**MEMORANDUM**

**Subject:** Review Response for Third Geological Review Matt Rasmussen Hillside Review  
6472 South Bybee Drive, Ogden, Utah, 84403 SA Project No. 15-140

GeoStrata has received review questions of our report titled **Review Response for Geological Review – 6472 and 6498 South Bybee Drive, Weber County Parcel Numbers: 07-753-0001 and 07-753-0002 Uintah, Weber County, Utah, SA Project Number 15-140**, GeoStrata Job Number 910-001 and dated July 9, 2015. This report was prepared for Mr. Matt Rasmussen and submitted to Weber County for review. Mr. Alan Taylor of Taylor Geotechnical (TG) prepared a review of our report. This memorandum was prepared in response to a series of review questions prepared by Mr. Taylor and dated August 5, 2015.

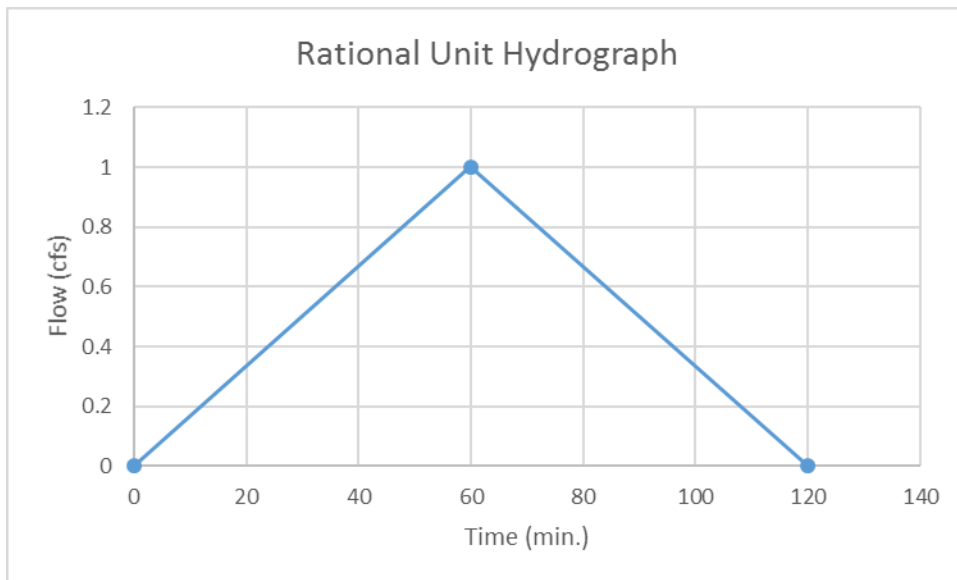
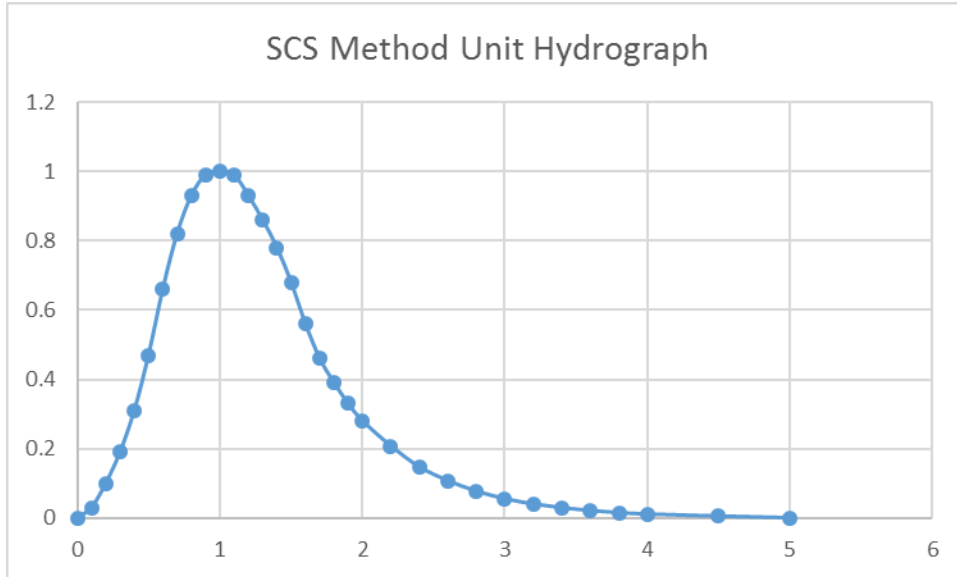
4. *Provide a copy of the "...unit rational hydrograph..." used to estimate a peak debris flow volume of 48.9 cfs for the property and provide hand calculations and data to validate a peak debris flow volume of 48.9 cfs.*

**GeoStrata Response:** Unit hydrographs from the SCS method and the rational method of hydrological analysis are presented below.

It is assumed that when the reviewer asks for data relating to “peak debris flow volume of 48.9 cfs” that it does not refer to the volume of a debris flow, but to the rate of flow.

Our analysis shows that the peak flow calculated from the rational unit hydrograph gives a more conservative result; therefore, this method was used in the design of the channel cross section.

### Broad Hollow WS

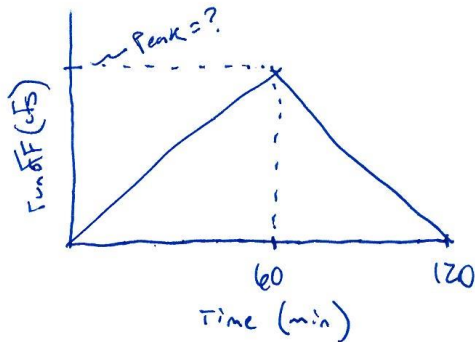
2. Specify all variables used in calculating debris flow volume for the property in the July 9, 2015, GeoStrata Memorandum, such as:
  - a. *S* (basin area with slopes greater than or equal to 30%, sq km);
  - b. *B* (basin area burned at moderate and high severity, sq km); and,
  - c. Rainfall data obtained from the NOAA Atlas 14, Volume 1, Version 5 Point Precipitation Frequency Estimates for the subject drainage basin (i.e. *R*, total storm rainfall, mm) (i.e., presumably "... a rainstorm event with a 10-year recurrence interval and 60 minute duration).

3. *Provide hand calculations to support the estimated debris flow volume of 4-acre feet (i.e., associated with "... a rainstorm event with a 10-year recurrence interval and 60 minute duration).*

A printout of our calculations, showing inputs and outputs for the regression model is included as Plate 1. Based on our calculations, the fire related debris flow volume predicted by the Cannon and others (2010) intermountain western United States post-wildfire debris flow regression model for a maximum rainstorm event with a 10-year recurrence interval and a 60 minute duration is 6.2 acre-feet.

**GeoStrata Response:** A printout of our calculations, showing inputs and outputs for the Cannon and others (2010) regression model is included as Plate 1.

Trapezoidal channel

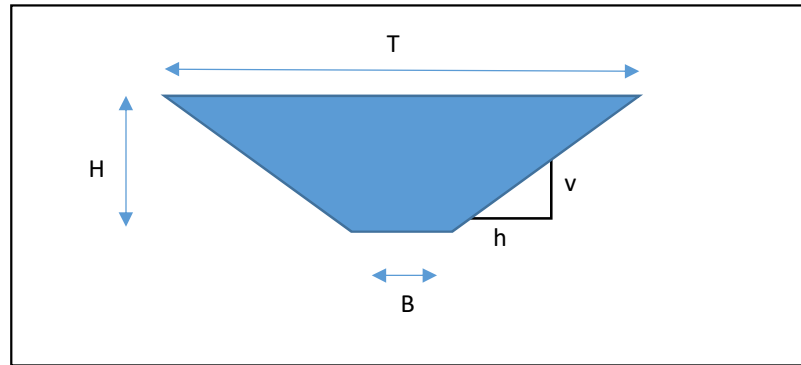
5. Provide hand calculations that substantiate “Velocity of the debris flow at peak flows will be 12.7 feet per second.”

**GeoStrata Response:** As the debris flow volume and flow rates have changed, so has the calculated debris flow velocity at peak flows. The updated calculation for debris flow velocity at peak flow is 13.0 feet per second. Calculations are attached as Plate 3.
